Approved Section 4.55 (.....2.....) Modification Application

No.....2..... Granted on ...28 January 2020

Goulburn Hospital & Health Service Redevelopment

SITE PLAN - DEMOLITION - S4.55 MODIFICATION APPLICATION

10406.00 AA-02-02 B

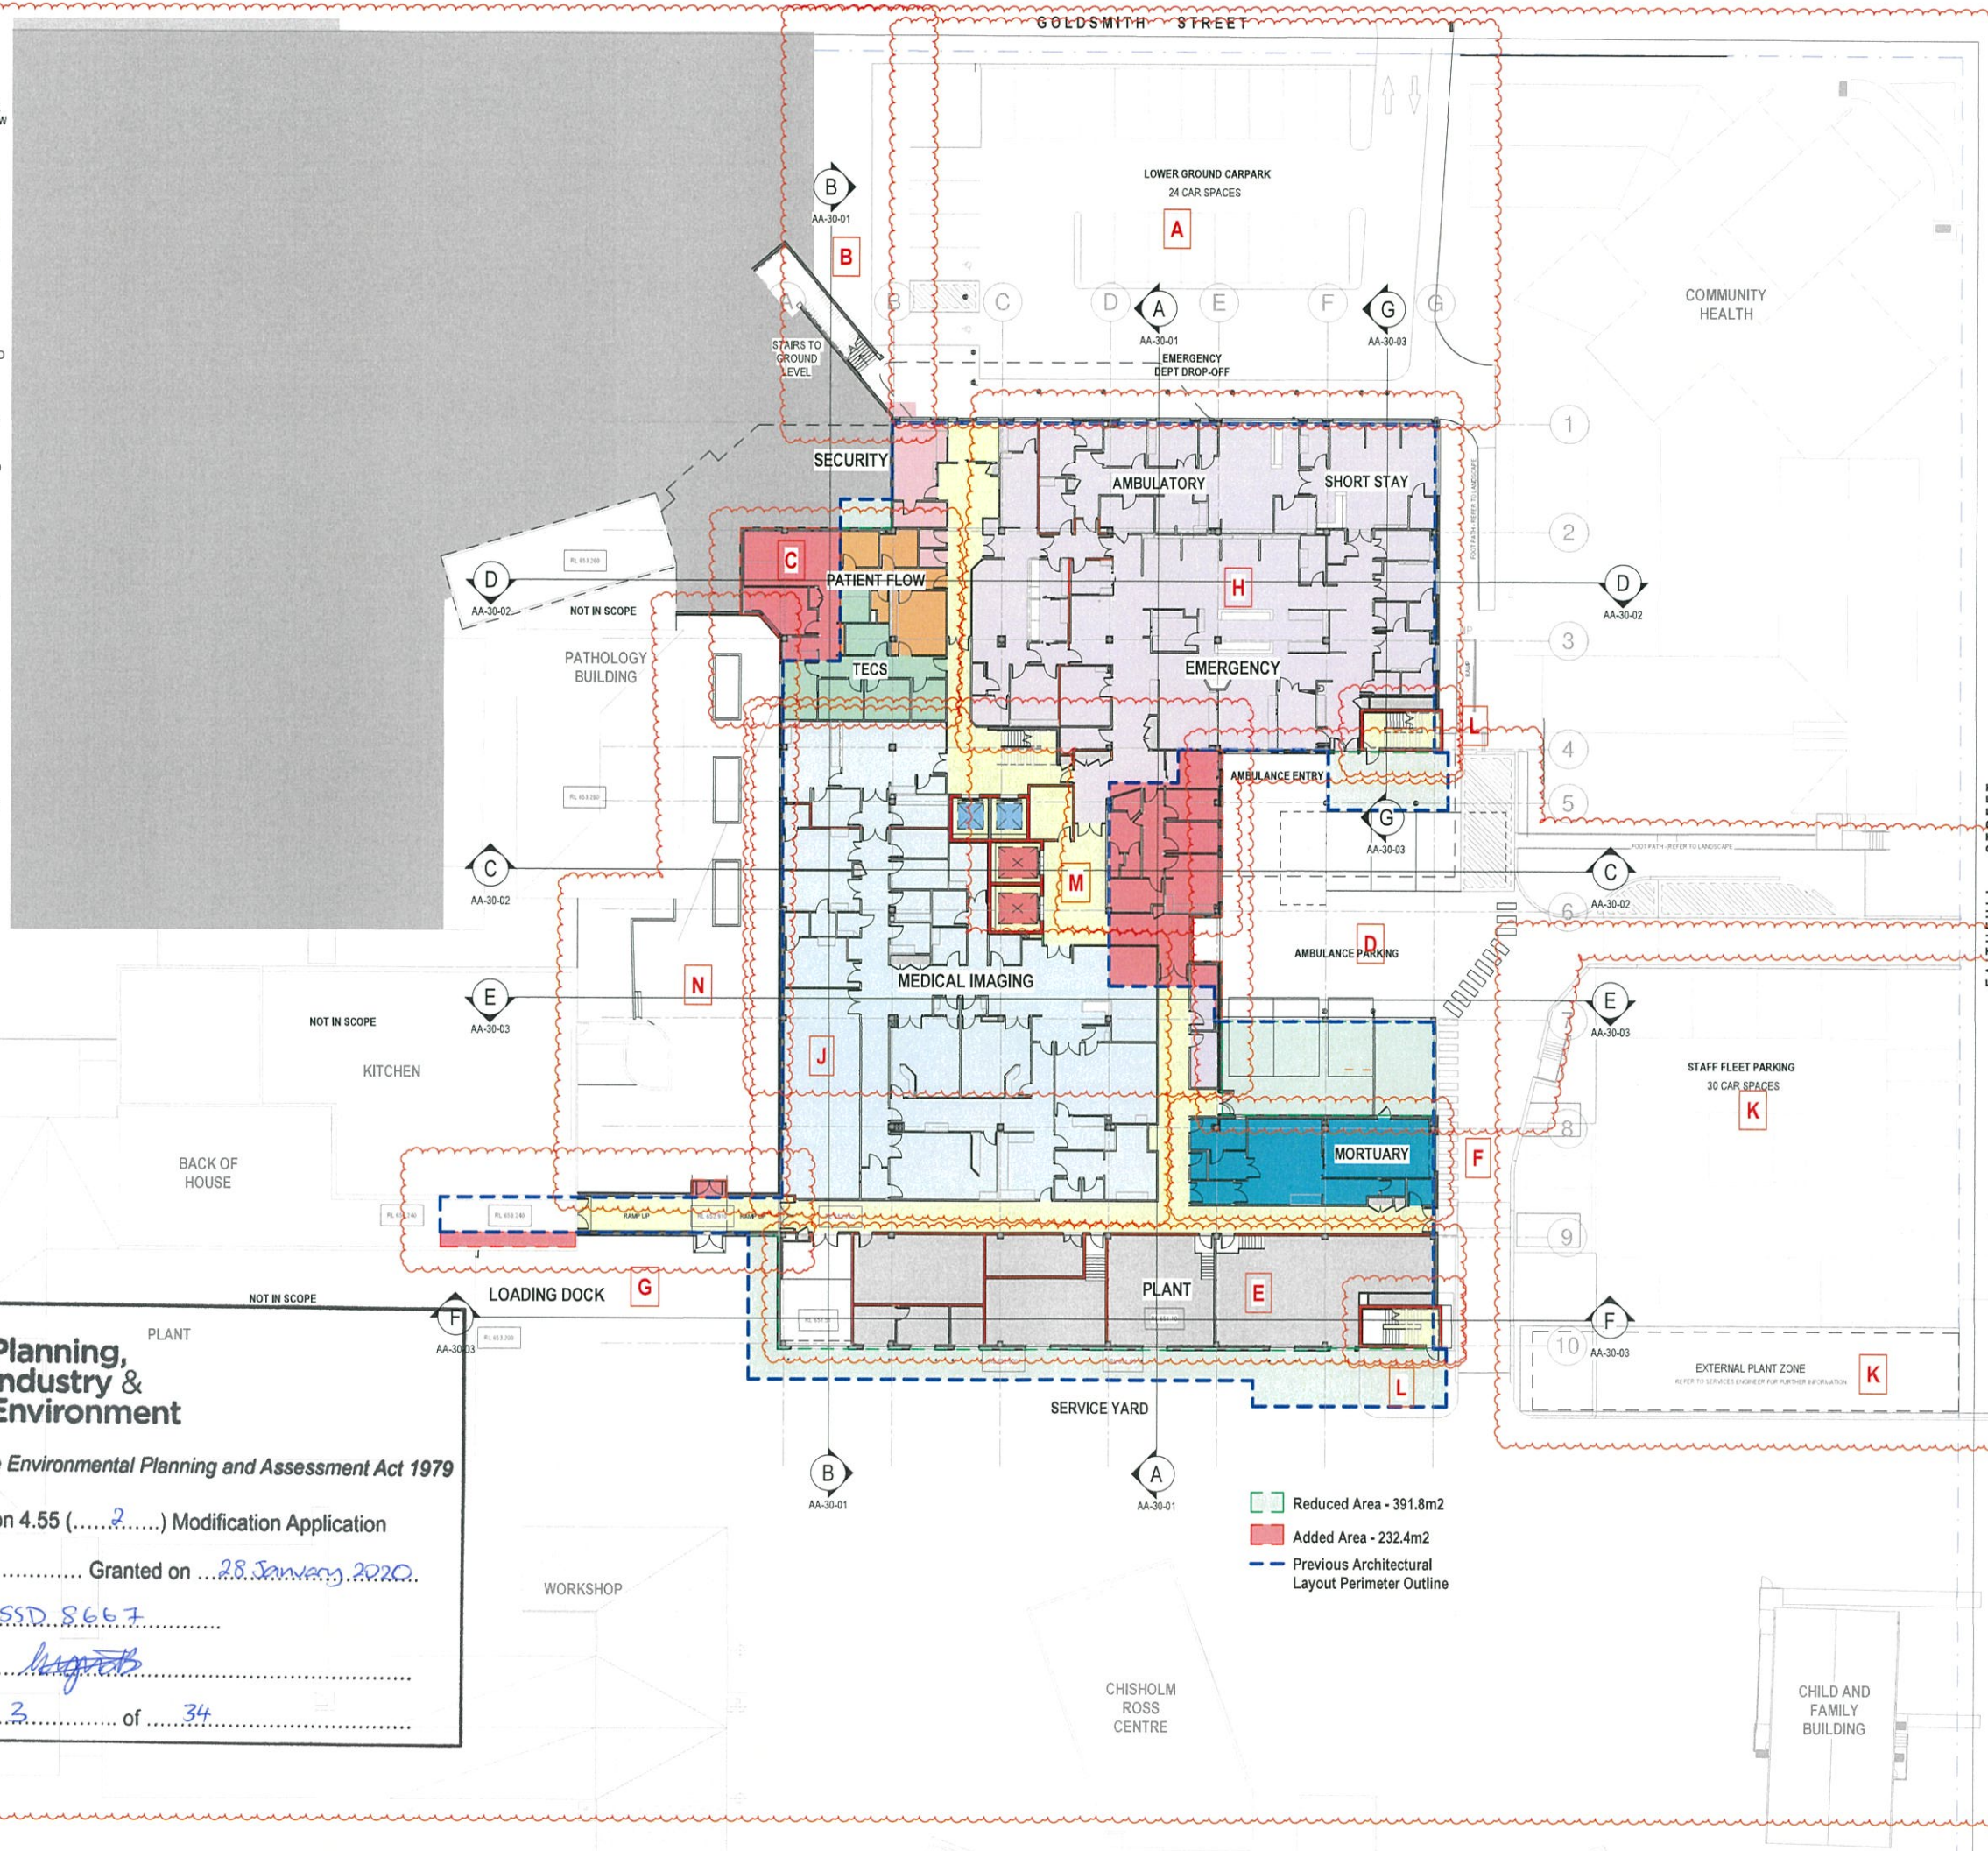
A	EMERGENCY DEPARTMENT CARPARK & DROP-OFF AREA AMENDED TO SUIT NEW LAYOUT AND HOSPITAL ENTRY 24 SPACES PROVIDED IN LIEU OF APPROVED 19 SPACES
B	MAIN HOSPITAL ENTRY RAMP / STAIRS REMOVED AND REPLACED WITH EXTERNAL STAIR TO MAIN ENTRY ONLY
C	PATIENT FLOW & TECS DEPARTMENTS RELOCATED
D	AMBULANCE ENTRY, ACCESS AND PARKING LAYOUT AMENDED
E	HOSPITAL SERVICES PLANT RELOCATED FROM EASTERN SIDE TO SOUTHERN SIDE
F	MORTUARY AND HEARSE PARKING BAY ADDED TO FACILITY
G	LOGISTICS AND LOADING DOCK LINK TO EXISTING BUILDINGS AMENDED TO BE MORE DIRECT ROUTE
H	EMERGENCY DEPARTMENT PLANNING AMENDED FOR IMPROVED FUNCTIONALITY
J	MEDICAL IMAGING PLANNING AMENDED FOR IMPROVED FUNCTIONALITY
K	STAFF FLEET CARPARK LAYOUT AND ACCESS AMENDED 32 SPACES PROVIDED IN LIEU OF APPROVED 29 SPACES EXTERNAL SERVICES PLANT AMENDED TO SUIT AS-BUILT CONDITIONS
L	FIRE EGRESS STAIRS MOVED WITHIN BUILDING FROM BEING EXTERNAL TO BUILDING IN APPROVED PLANS

M	BUILDING FOOTPRINT WIDENED AT LIFT CORE AND CENTRAL AREA LIFT CORE REVISED TO ROTATE SERVICES LIFTS TO FACE EAST
N	LANDSCAPED COURTYARD TO WEST SIDE OF NEW BUILDING BETWEEN EXISTING BUILDINGS FOR STAFF ACCESS ONLY

-  Reduced Area - 391.8m²
-  Added Area - 232.4m²
-  Previous Architectural Layout Perimeter Outline

**PRECINCT PLANS - LOWER
GROUND - \$4.55
MODIFICATION APPLICATION**

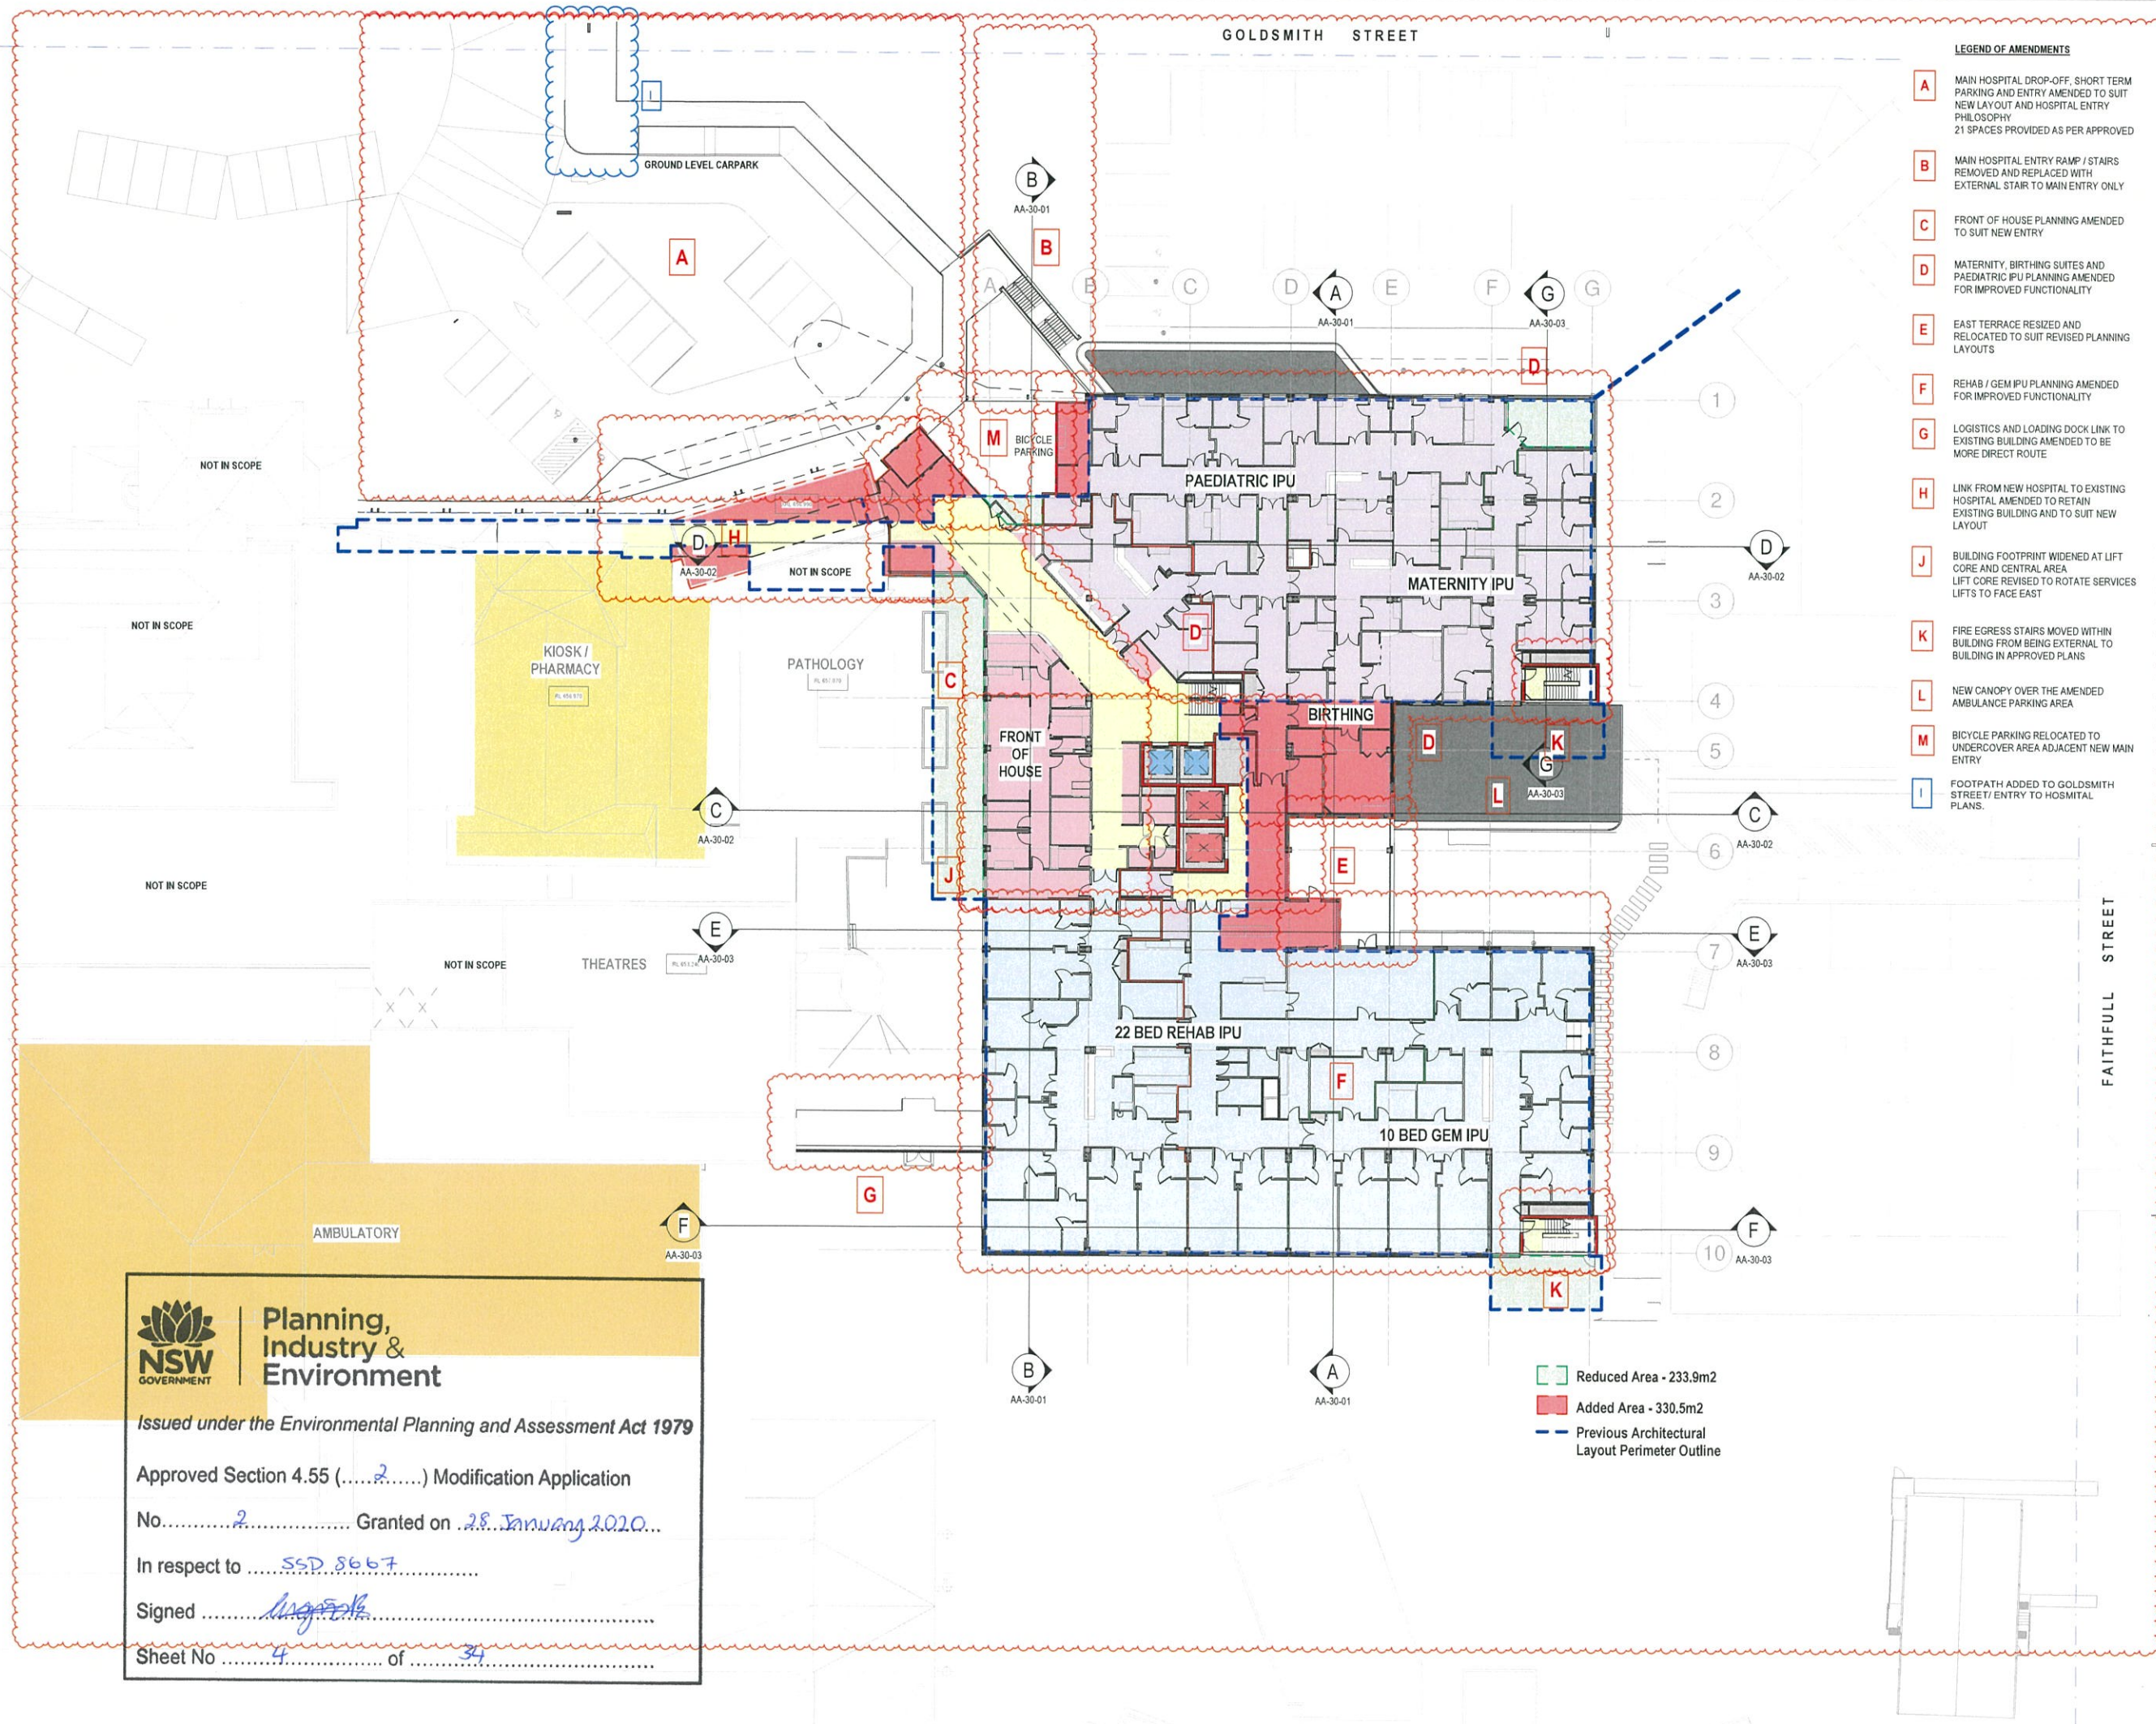
- LEGEND OF AMENDMENTS**
- A** MAIN HOSPITAL DROP-OFF, SHORT TERM PARKING AND ENTRY AMENDED TO SUIT NEW LAYOUT AND HOSPITAL ENTRY PHILOSOPHY
21 SPACES PROVIDED AS PER APPROVED

- B** MAIN HOSPITAL ENTRY RAMP / STAIRS REMOVED AND REPLACED WITH EXTERNAL STAIR TO MAIN ENTRY ONLY
 - C** FRONT OF HOUSE PLANNING AMENDED TO SUIT NEW ENTRY

- D** MATERNITY, BIRTHING SUITES AND PAEDIATRIC IPU PLANNING AMENDED FOR IMPROVED FUNCTIONALITY
 - E** EAST TERRACE RESIZED AND RELOCATED TO SUIT REVISED PLANNING LAYOUTS

- F** REHAB / GEM IPU PLANNING AMENDED FOR IMPROVED FUNCTIONALITY
 - G** LOGISTICS AND LOADING DOCK LINK TO EXISTING BUILDING AMENDED TO BE MORE DIRECT ROUTE

- H** LINK FROM NEW HOSPITAL TO EXISTING HOSPITAL AMENDED TO RETAIN EXISTING BUILDING AND TO SUIT NEW LAYOUT
 - J** BUILDING FOOTPRINT WIDENED AT LIFT CORE AND CENTRAL AREA
LIFT CORE REVISED TO ROTATE SERVICES LIFTS TO FACE EAST

- K** FIRE EGRESS STAIRS MOVED WITHIN BUILDING FROM BEING EXTERNAL TO BUILDING IN APPROVED PLANS
 - L** NEW CANOPY OVER THE AMENDED AMBULANCE PARKING AREA

- M** BICYCLE PARKING RELOCATED TO UNDERCOVER AREA ADJACENT NEW MAIN ENTRY
 - I** FOOTPATH ADDED TO GOLDSMITH STREET/ ENTRY TO HOSPITAL PLANS.
